2021 Long-Term Electric Resource Plan (LTERP) and Long-Term Demand-Side Management Plan (LT DSM Plan) (Application) – Project No. 1599244

Response to the British Columbia Utilities Commission (BCUC) Information Request (IR) No. 2

FortisBC Inc. (FBC or the Company) 2021 Long-Term Electric Resource Plan (LTERP) and Long-Term Demand-Side Management Plan (LT DSM Plan) (Application)	Submission Date: March 31, 2022
Response to British Columbia Utilities Commission (BCUC) Information Request (IR) No. 2	Page 1

Figure 4-1-A

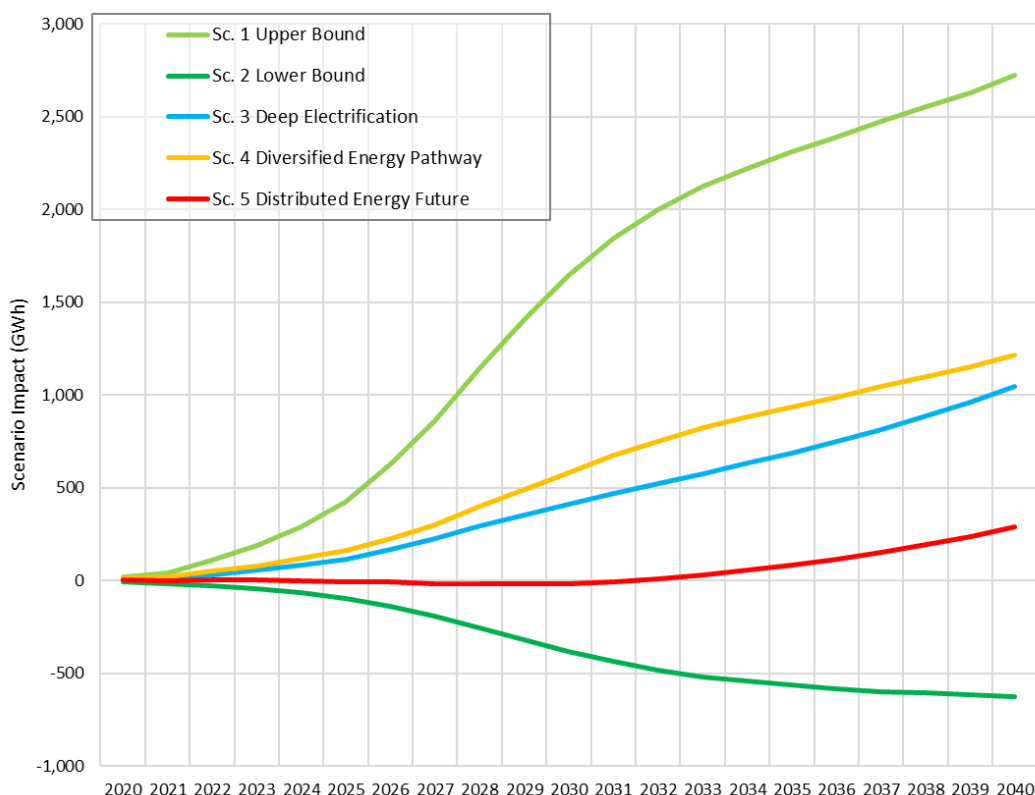
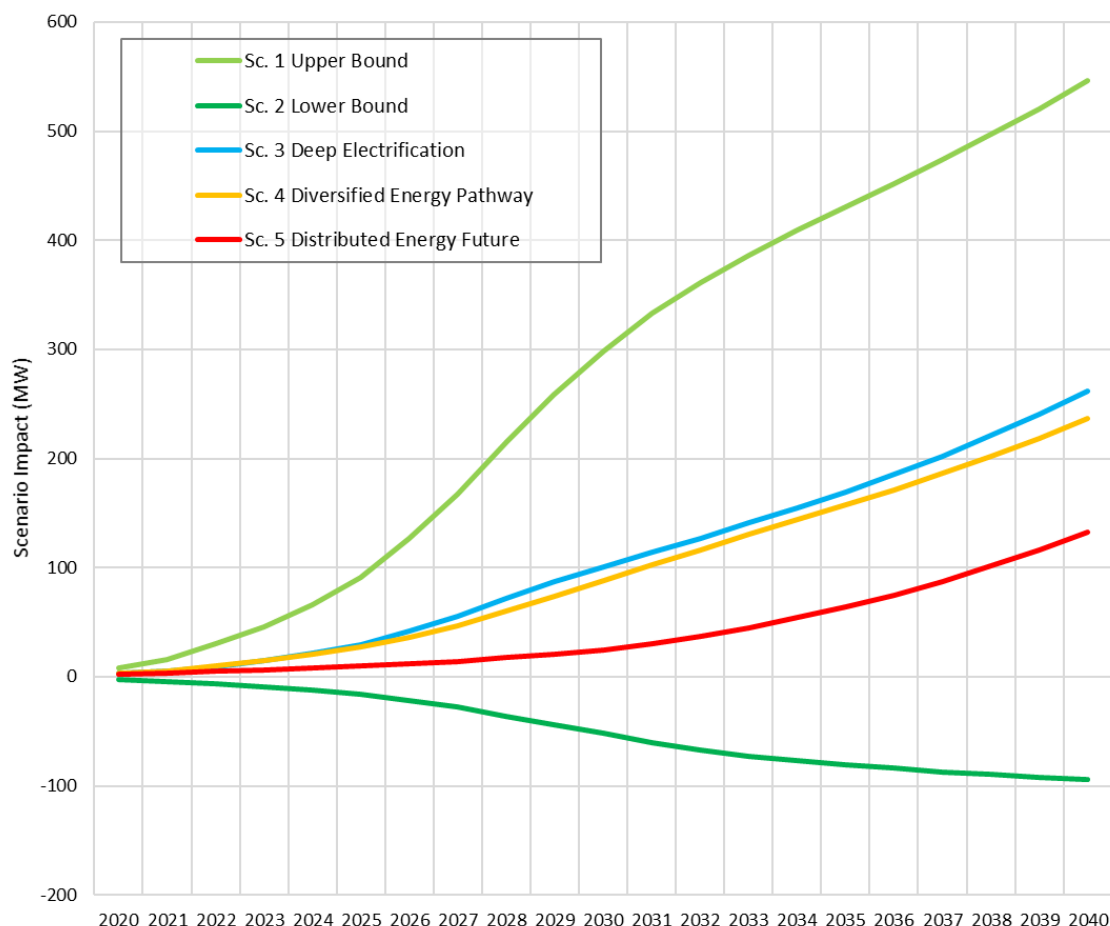
48.2 Please provide analysis showing the impact on the scenarios of holding both of these assumptions constant between Scenario 3 and Scenario 4.

If the same assumptions for Scenario 3 regarding data centre and cannabis production floor space are applied to Scenario 4, the annual energy for Scenario 4 decreases by 133 GWh by 2040 and the winter peak demand decreases by 14 MW by 2040. The following updated Figure 4-1 from Section 4.1.3 (captioned Figure 4-1-A below) shows the resulting impacts of these changes on annual energy for each scenario.

1 The following updated Figure 4-2 from Section 4.1.3 (captioned Figure 4-2-A below) shows the
 2 resulting impacts of these changes on peak winter demand for each scenario.

Figure 4-1-A

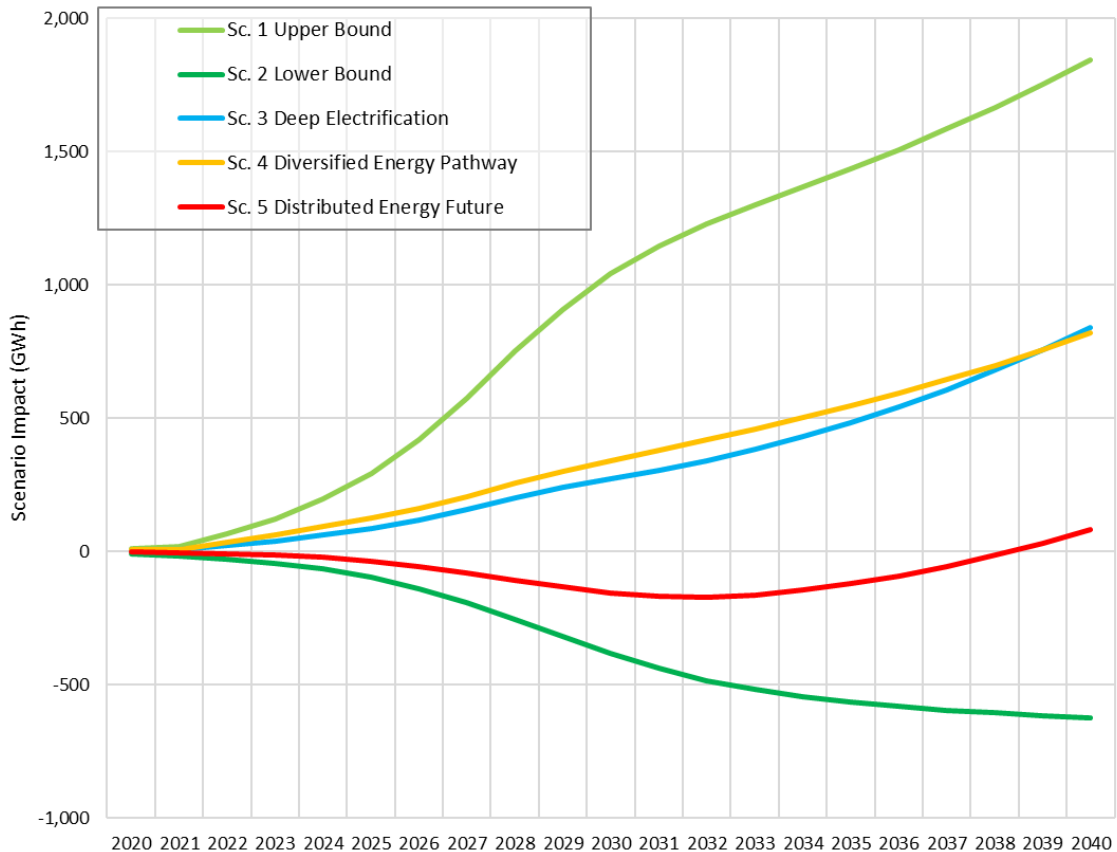
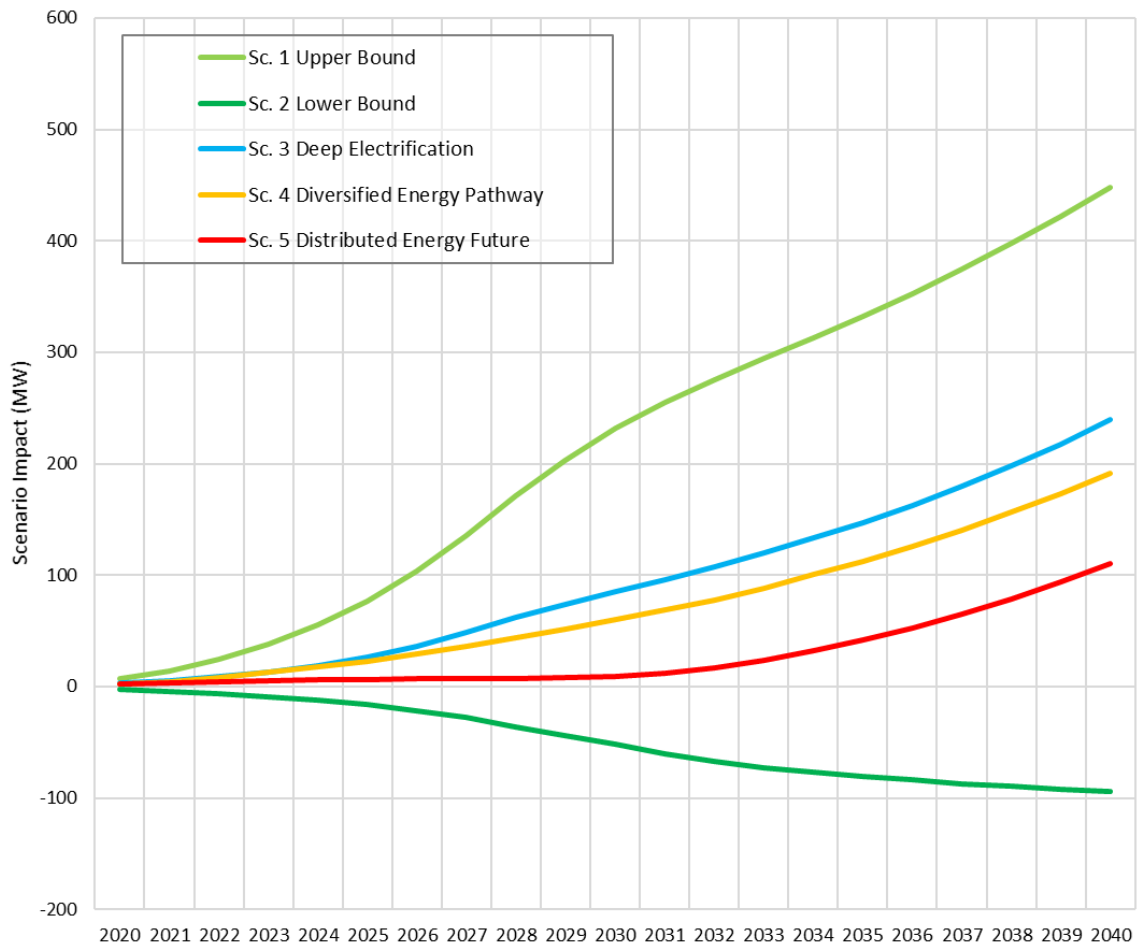
48.4 Please provide an analysis showing the impact of removing the hydrogen load driver from the scenarios.

The following updated Figure 4-1 from Section 4.1.3 (captioned Figure 4-1-A) shows the resulting impacts of these changes on annual energy for each scenario.

3 The following updated Figure 4-2 from Section 4.1.3 (captioned Figure 4-1-B) shows the resulting
 4 impacts of these changes on peak winter demand for each scenario.
